**Environmental
Protection Agency**

July 12, 2010

RE: SUMMIT COUNTY
MUD BROOK BASIN
CITY OF STOW
SEASONS ROAD IMPROVEMENT PROJECT

Figure 1. Heavy sediment deposition was observed within "waters of the State."

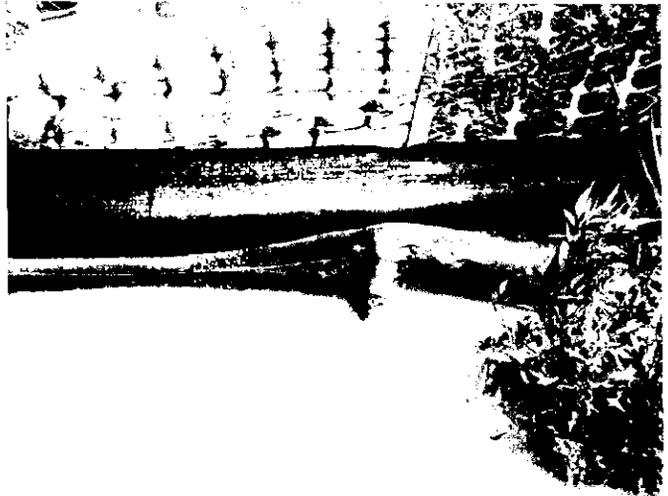
- Silt fence was observed to be damaged. Sediment-laden water was observed in the wetland outside of the construction limits (Figures 1 and 2). The silt fence is the primary sediment control between the project and the adjacent wetlands. Immediately repair or reinstall silt fence in accordance with the site's storm water pollution prevention plan (SWP3).
- Very few ditch checks were installed (Figures 3 and 4). Install ditch checks in accordance with the site's SWP3.
- Improper inlet protection has been installed (Figure 5). Remove and reinstall inlet protection in accordance with the site's SWP3.
- Some areas of the site appeared to be in need of stabilization (Figures 6 and 7). Stabilize all areas of the site that will remain idle for 21 days or longer or that are at final grade.
